**Title:           QUALITY AUDIT**  
**INCLUDING ROAD SAFETY AUDIT STAGE 1**  
**Proposed Student Accommodation (SHD), 'The Grove'**  
**Goatstown.**

**Client:         DBFL Consulting Engineers**

**Date:          January 2021**

**Report reference: 0933R01**

Drawing 1522-300 Rev 9, TBS

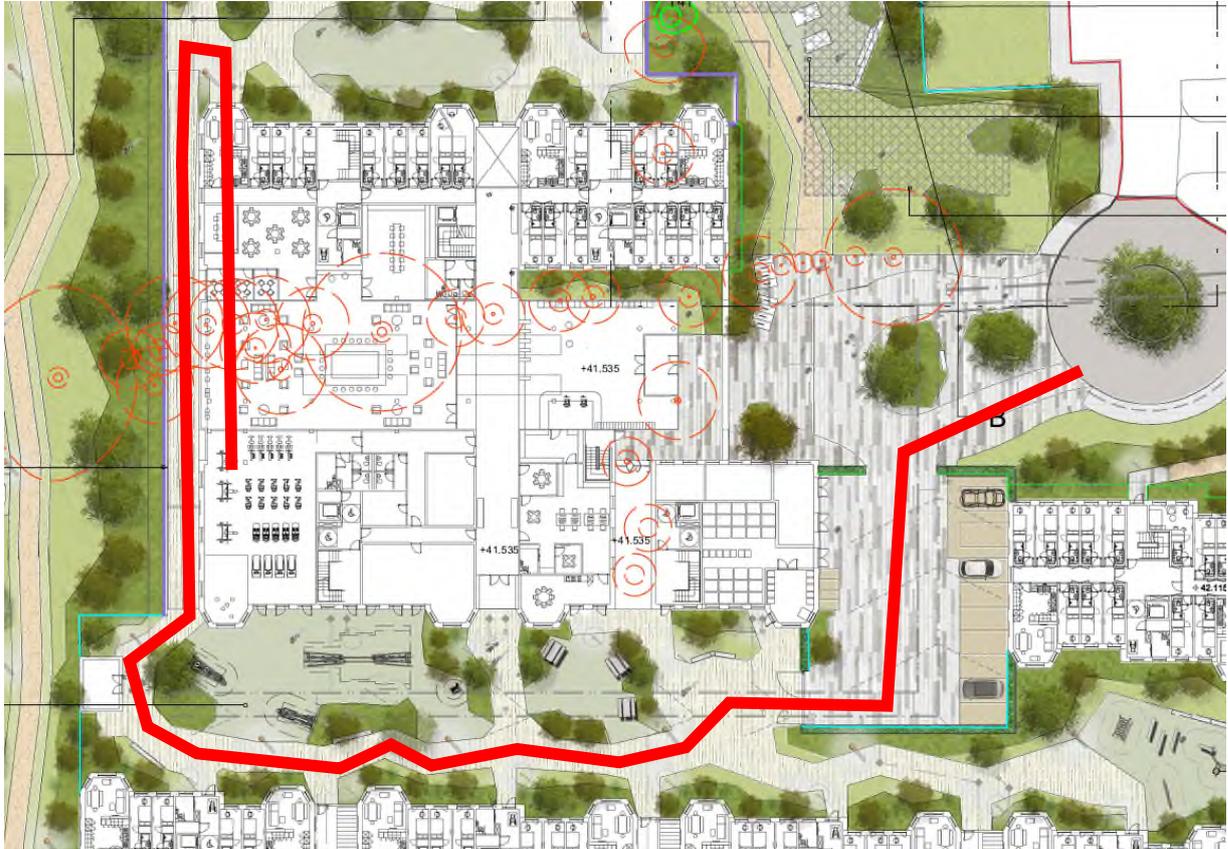
There is a long and arduous route for cyclists to enter /exit the main bicycle parking area in the lower ground including a journey through the recreational area and along the ramp at the western side of the main block. There is a risk that cyclists will abandon their bicycles outside in more convenient areas where they may be hazards for cyclists.

It is recommended that a more direct route to the bicycle parking be provided for cyclists.

3.4	NO	NO	The development is a fully managed facility and residents will not be permitted to leave bikes in unauthorised locations.	Yes

Drawing 200012-DBFL-RD-SP-DR-C-1001 P02, Roads Layout.

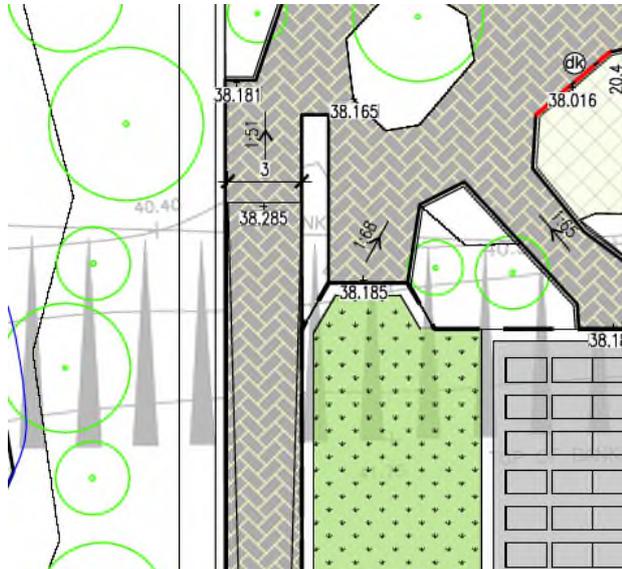
There ramp for cyclists and pedestrians to the west of the main block is proposed to be 3.0m wide. The effective width will be less given that there will be walls on both sides. The usage of this ramp is expected to be high given it is on the route to/from the main bicycle parking area and it links with the recreational area. The relatively narrow width could lead to collisions between cyclists and pedestrians particularly when cyclists are travelling downhill.

It is recommended that the ramp be widened to comfortably accommodate the proposed usage by both pedestrian and cyclists or that separate facilities be provided for cyclists.

Paragraph No. in Quality Audit Report	Problem accepted (yes/no)	Recommended measure accepted (yes/no)	Alternative measures (describe)	Alternative measures accepted by Auditors (Yes/No)
3.5	YES	NO	Cyclists will be requested to dismount and walk the bikes down / up the ramp.	Yes
3.6	YES	YES		
3.7	YES	YES

Drawing 1522-300 Rev 9, TBS

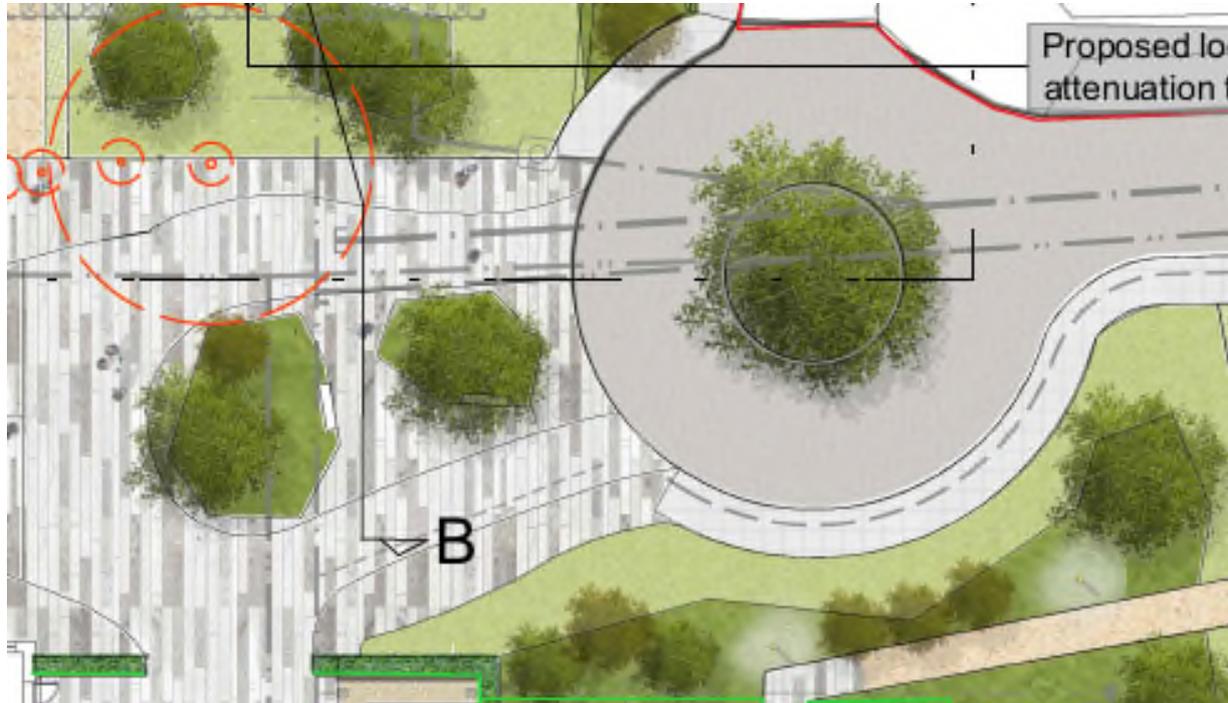
It is proposed to provide a separate access and egress from the roundabout to the development (almost like a second roundabout/gyratory) that will be a shared space for drivers and vulnerable road users. These users must be made aware that they are entering a roundabout and have to give way to traffic on their right. The roundabout will be busy during school term. There is also a proposal to have overhanging trees planted within the central island of the roundabout which may alter drivers perception of the roundabout and also change their usual driving line to avoid the branches.

It is recommended that the roundabout be treated as a public road roundabout in compliance with the Traffic Signs Manual. The entry and exit from the development should be clearly defined to avoid head-on collisions. In addition, any planting in the central island should not be a hazard with regard to visibility or obstruction.

Drawing 200012-DBFL-RD-SP-DR-C-1001 P02, Roads Layout.

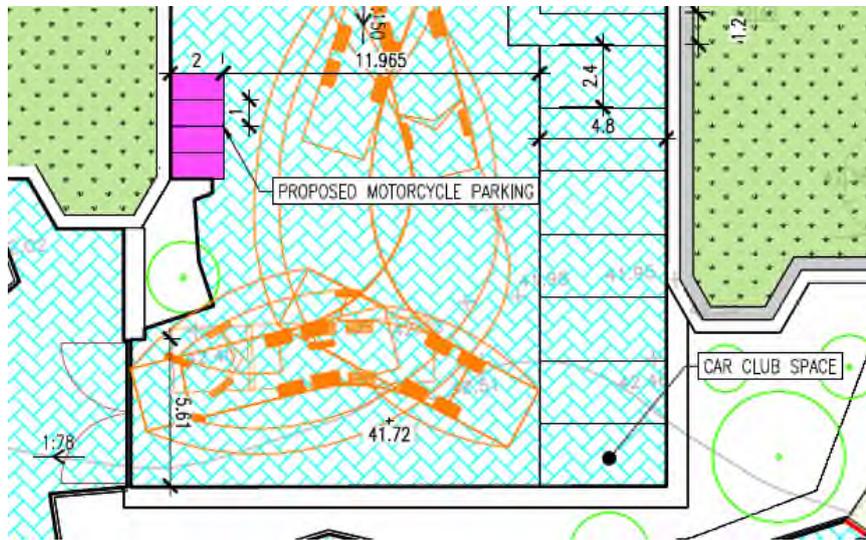
The swept path for the refuse vehicle is shown on the drawing. It is unclear however where the bins will be stored on collection day. There is a risk that bins may be left where they block pedestrian or cyclist routes.

It is recommended that the temporary bin storage areas be shown on the drawings so that they can be assessed for safety and accessibility.
